Project No. 620.11743.00016

RE: Yarrabilba Precinct 9

EDQ Information Request – Response to Traffic Matters

YARRABILBA
PRECINCT 9 - APPLICATION 1
RECONFIGURATION OF A LOT - OVERALL

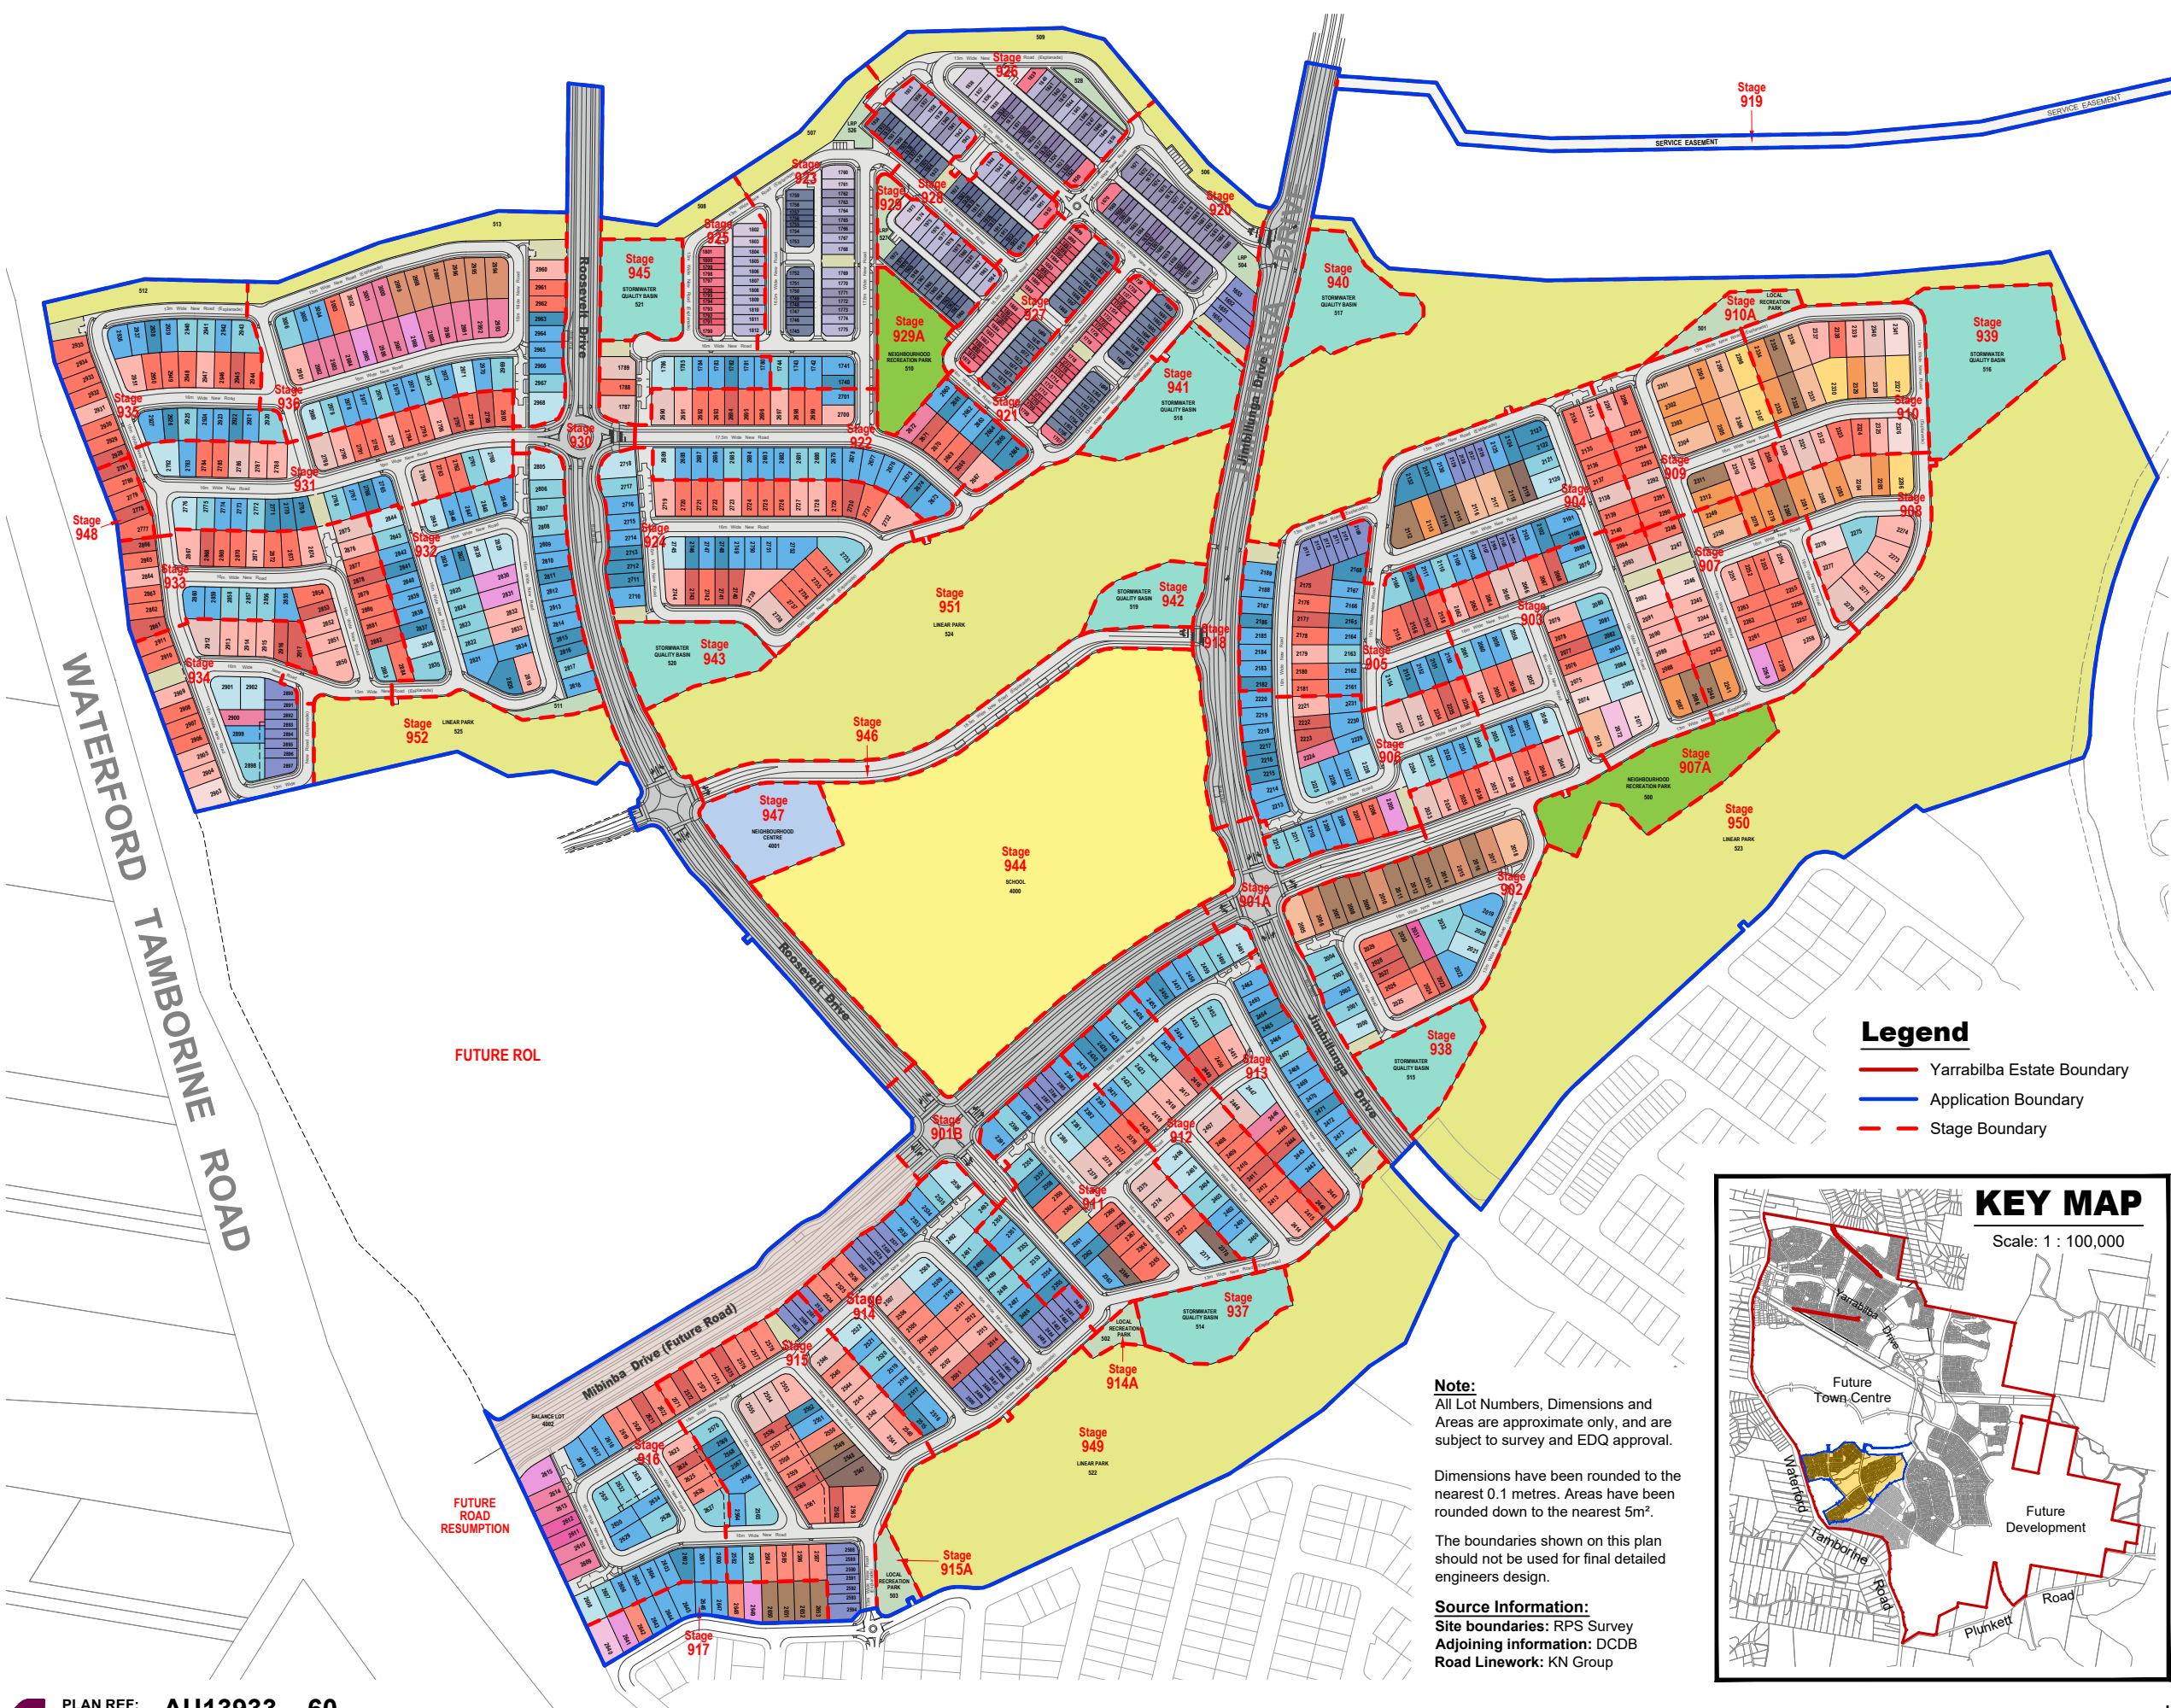
“Amend the proposal to include the road adjoining the future ROL site to the south in it’s own lot. EDQ has concerns regarding the timing of the delivery of this road. It is noted that the district sports park is required under the IA to be delivered by the 9,000th residential lot. This proposal will bring that total to approximately 8,600 lots.”

A separate Lot will be created for Mibinba Drive between Roosevelt Drive and Waterford-Tamborine Road. The latter is indicated on the revised ROL plans (by RPS) at **Appendix A**.

Appendix C Access and Bus Plan

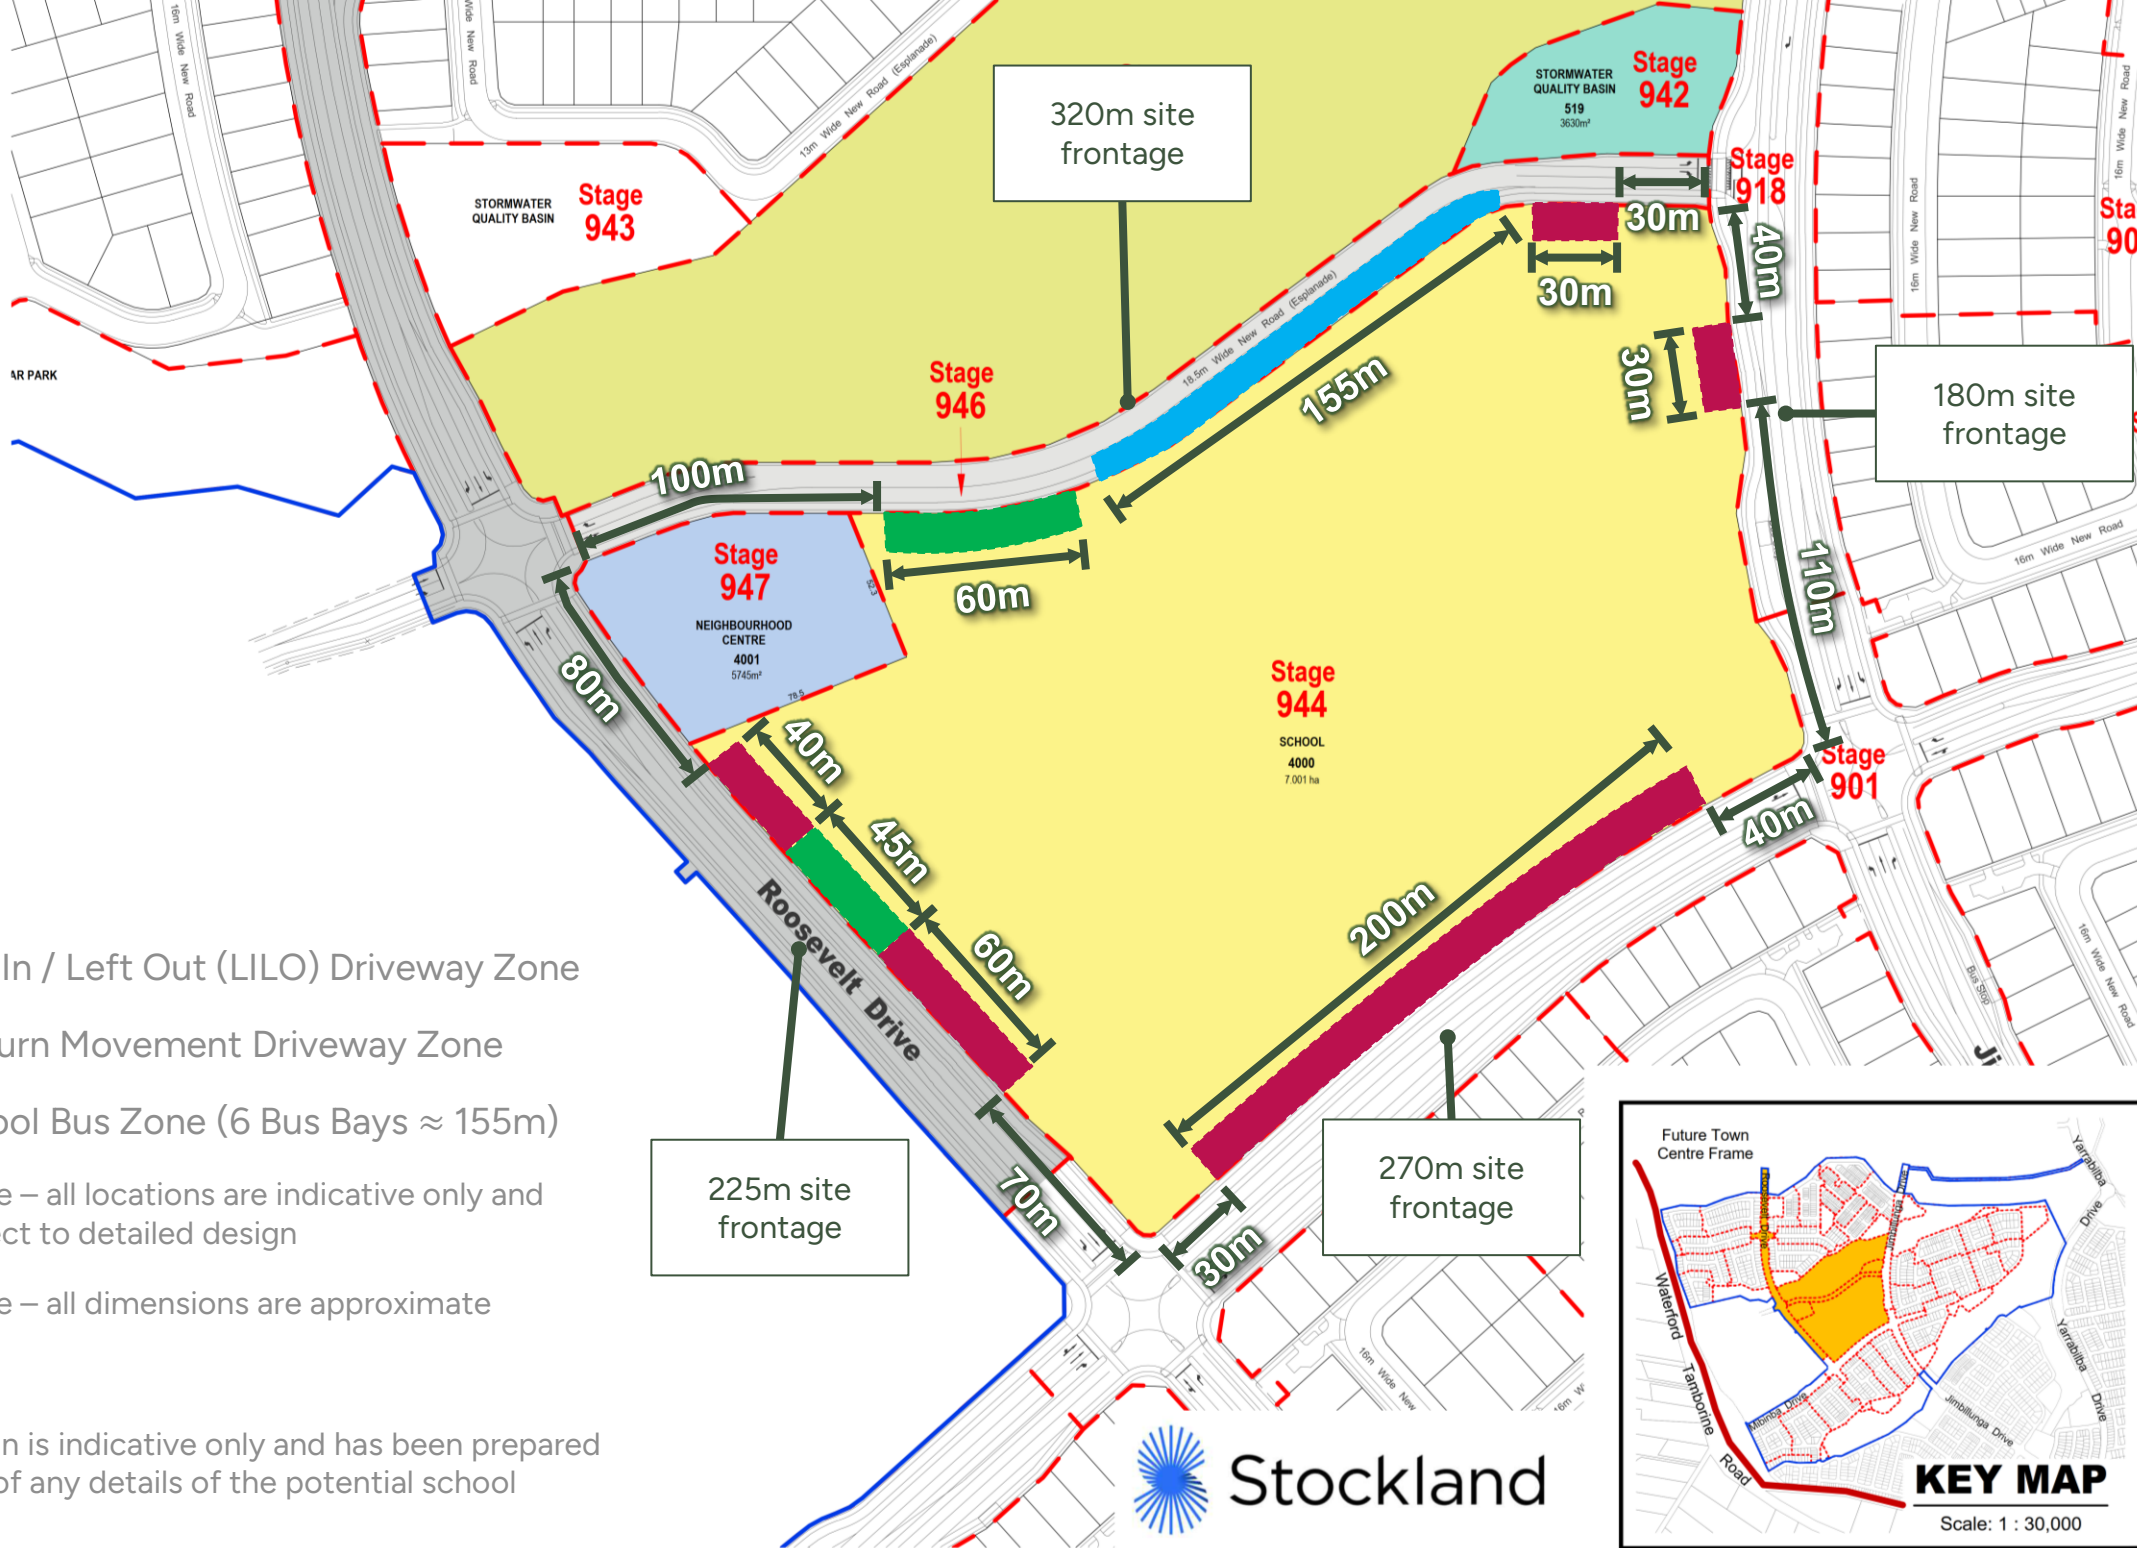
The road hierarchy as presented in the functional layout plans (site frontage to two sub-arterial roads) potentially reduces access opportunities to the site.

The development not meeting the requirements of the Department of Transport and Main Road Planning for Safe Transport Infrastructure at Schools, with respect to bus stops, and pedestrian and cycle movement and conflicts with motorised vehicles.

The location and form of access driveways for the school will be a matter for Department of Education to identify, as part of developing layout plans for the school. Whilst no such plans have been made available by EDQ, the markup plan at **Appendix C** has been prepared by SLR to show indicative locations where driveway access could be provided. In regard to the latter, all driveway locations are 'indicative only' and must comply with normal road design standards.

The markup plan at **Appendix C** confirms that there are multiple locations / opportunities for vehicle access for the school to/from the site, consistent with DTMR and DoE guidelines.

The Department of Education is responsible for delivery of the school and is therefore responsible for ensuring that the requirements of the Department of Transport and Main Roads (DTMR) “*Planning for Safe Transport Infrastructure at Schools*” are met. Notwithstanding the latter, the functional plans prepared for the Precinct 9 application, in conjunction with the markup access / bus zone plans at **Appendix C**, shows that infrastructure consistent with the DTMR requirements is achievable.
